**CITY OF SARATOGA SPRINGS
CITY COUNCIL WORK SESSION
AGENDA**

Author: Sarah Carroll
Worksession Date: January 20, 2015
Date of Memo: January 13, 2015
Re: Fitness center parking requirements, Section 19.09.11
VASA Fitness concept plan

Report Date:	December 24, 2014
Project Request / Type	Concept Plan
Applicant:	HD Saratoga, LLC / Charlie Hammond
Location:	~1523 North Redwood Road
Major Street Access:	Redwood Road
Parcel Number(s) and size:	66:242:0006, ~2 acres
General Plan Designation:	Regional Commercial
Zone:	Regional Commercial (RC)
Adjacent Zoning:	Regional Commercial (RC)
Current Use:	Vacant
Adjacent Uses:	Walmart, Zions Bank, T-Mobile, Dollar Cuts, Café Rio, O'Reilly Auto Parts, Panda Express
Previous Meetings:	Walmart Final Plat was approved 6-12-07
Land Use Authority:	Review required by PC and CC
Future Routing:	City Council
Planner:	Sarah Carroll, Senior Planner

Author: Kimber Gabryszak, AICP
Memo Date: Tuesday, January 13, 2015
Meeting Date: Tuesday, January 20, 2015
Re: Riverbend Medical Conditional Use Permit and Site Plan

VASA SARATOGA SITE PLAN

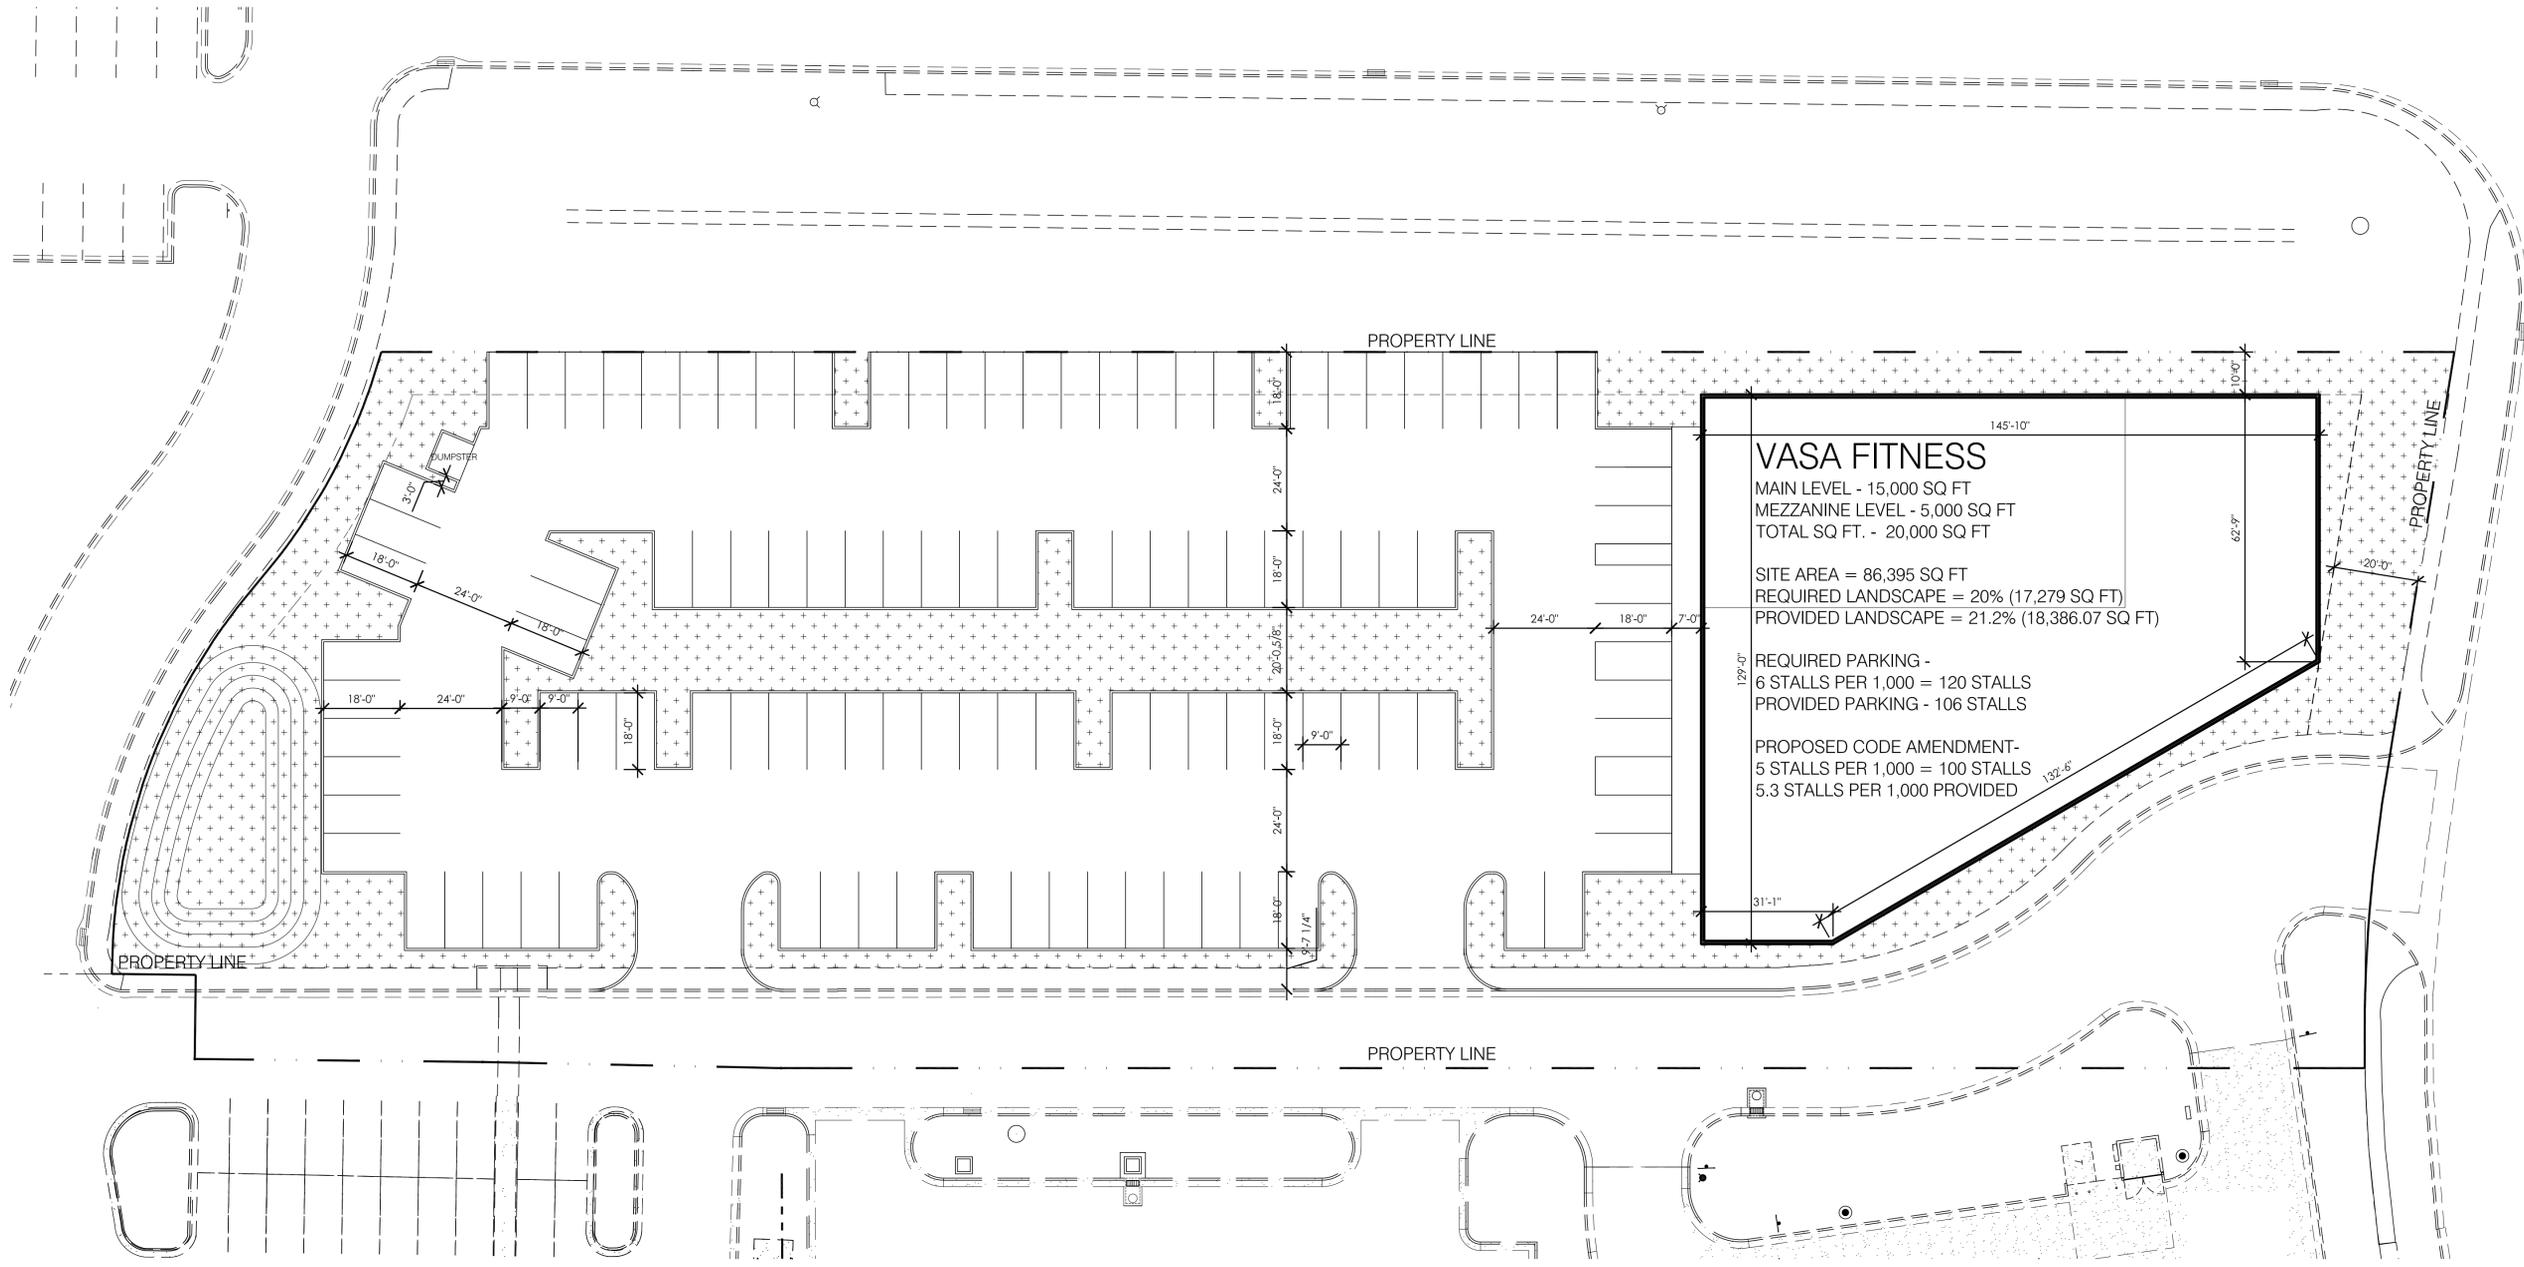
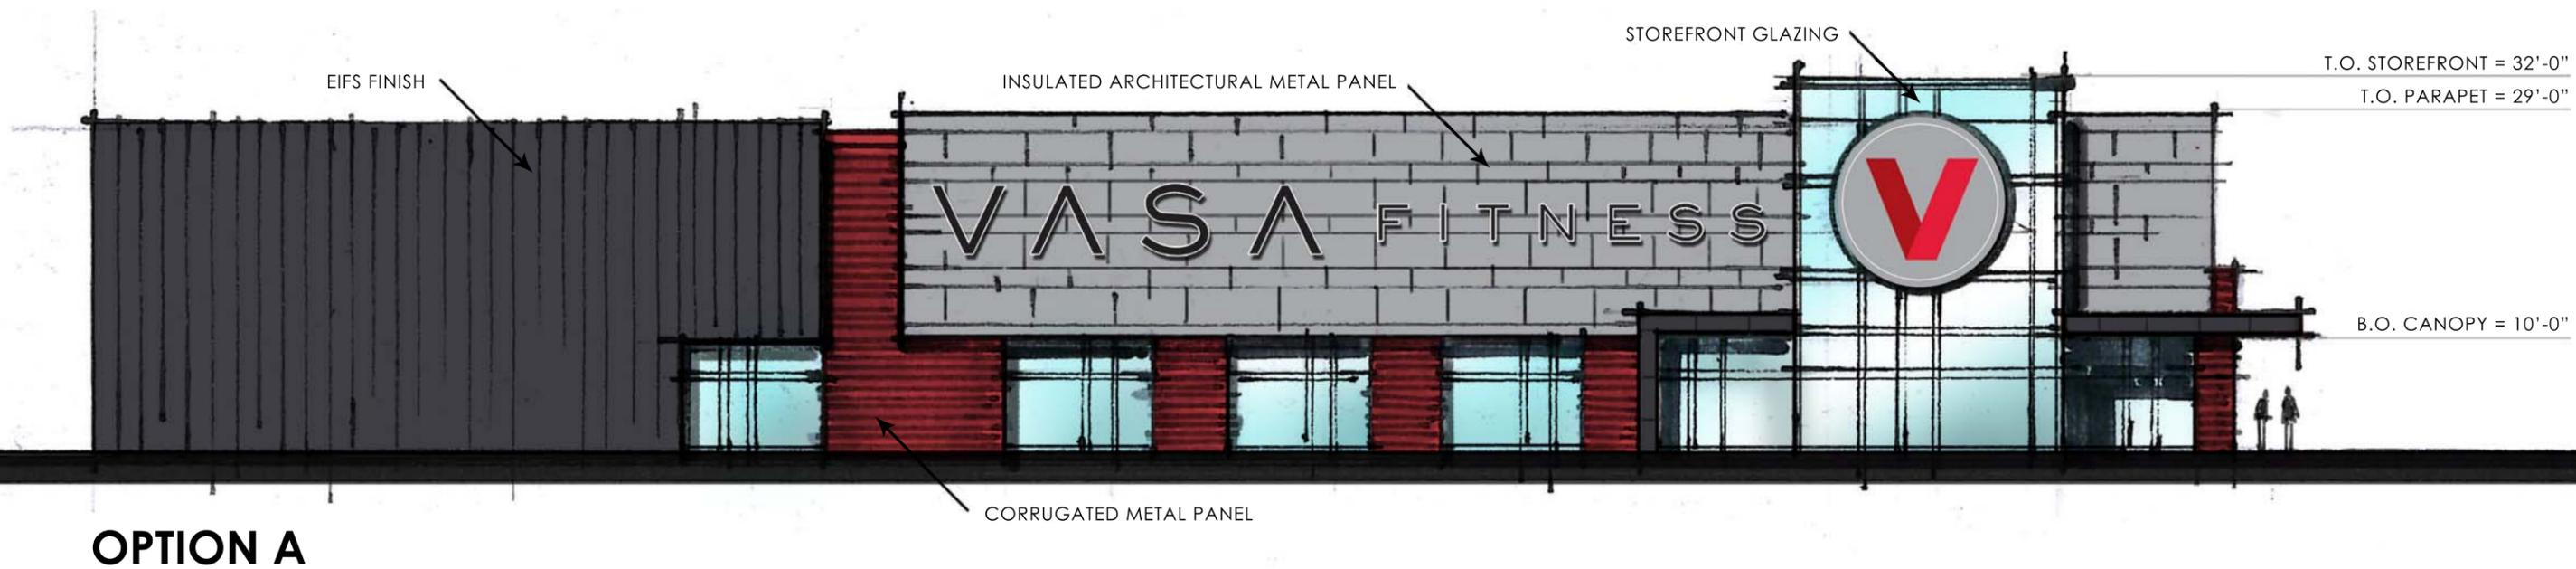
Parking: up for discussion. Section 19.09.11 requires specific numbers of parking stalls based on specific land uses and requires 6 stalls per 1000 square feet for fitness centers. *The concept plan indicates 5.3 parking stalls per 1000 square feet. The applicant has indicated that this requirement exceeds the requirements in other Cities and exceeds their needs based on typical use at their other sites and have submitted a request for a code amendment to reduce this requirement to 5 stalls per 1,000 square feet.*

REQUIRED PARKING -
 6 STALLS PER 1,000 = 120 STALLS
 PROVIDED PARKING - 106 STALLS

PROPOSED CODE AMENDMENT -
 5 STALLS PER 1,000 = 100 STALLS
 5.3 STALLS PER 1,000 PROVIDED

Jeff Cochran asked staff about the detention basin on the plan, could those be combined with the larger current basin to perhaps increase parking.

Jeff Cochran challenged the applicant to look at the parking again and see if they could possibly add a few more stalls.

Exhibit 5
Elevations

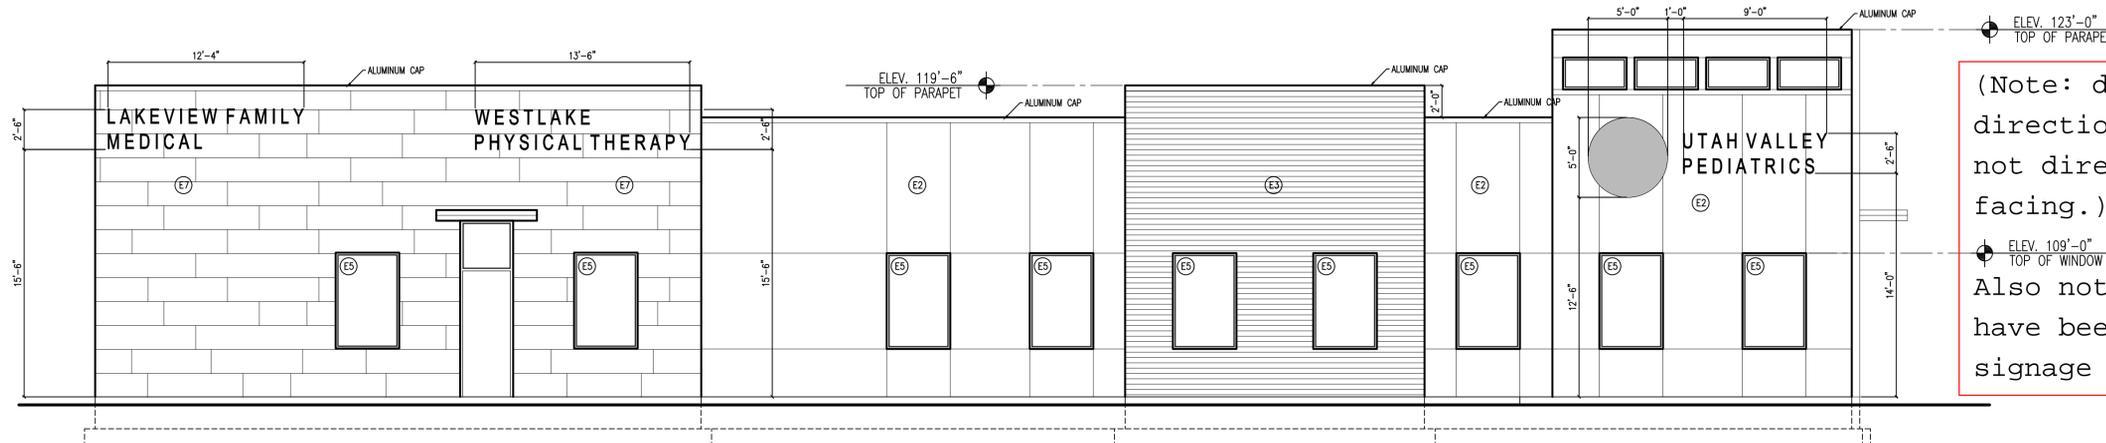
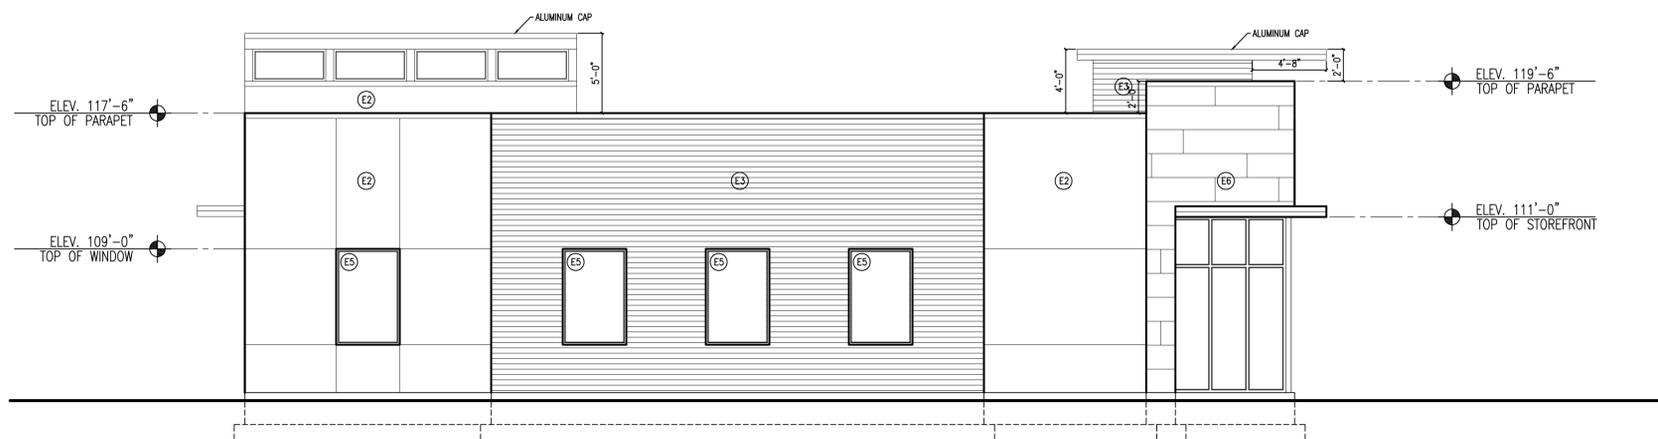
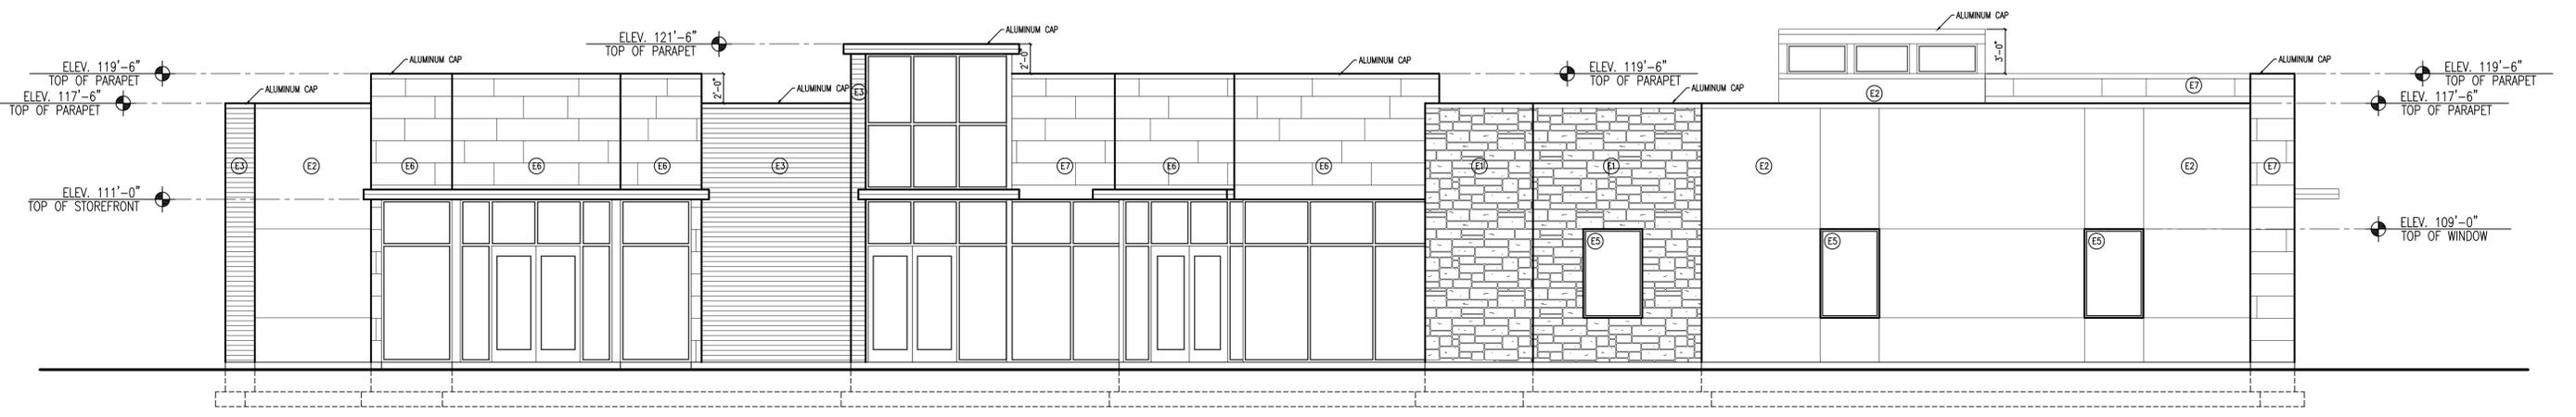
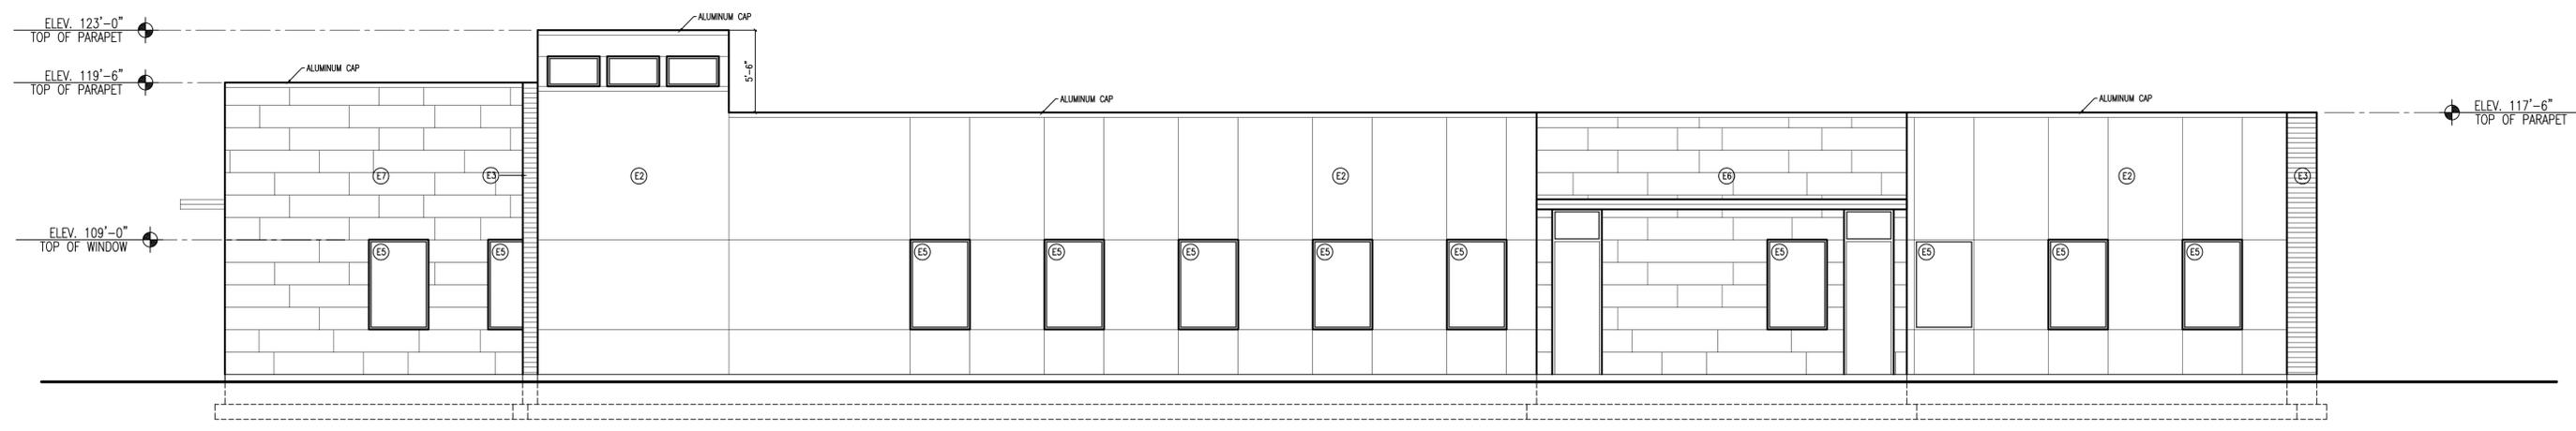
Sandra Steele asked if roof top equipment has an access from the inside. (Yes.) She asked that when he brings in the elevations that they show the percentage of each building material and give the lengths of the longer portions of each material to make sure they don't exceed the requirements. She thought the sign might exceed the height limit but won't know till they get the preliminary plat. She also noted that they need to have equal architectural treatment on all sides.

- The white stucco was used to compliment and contrast with the other colors and materials used on the building. It communicates a clean, professional Health Care Facility, which has its own identity and recognition.
- We can add more rock to break the white.
- The rooftop mechanical will be concealed partially by the parapet walls. A screen will be around each unit. TBD
- All materials used will be located on each elevation.
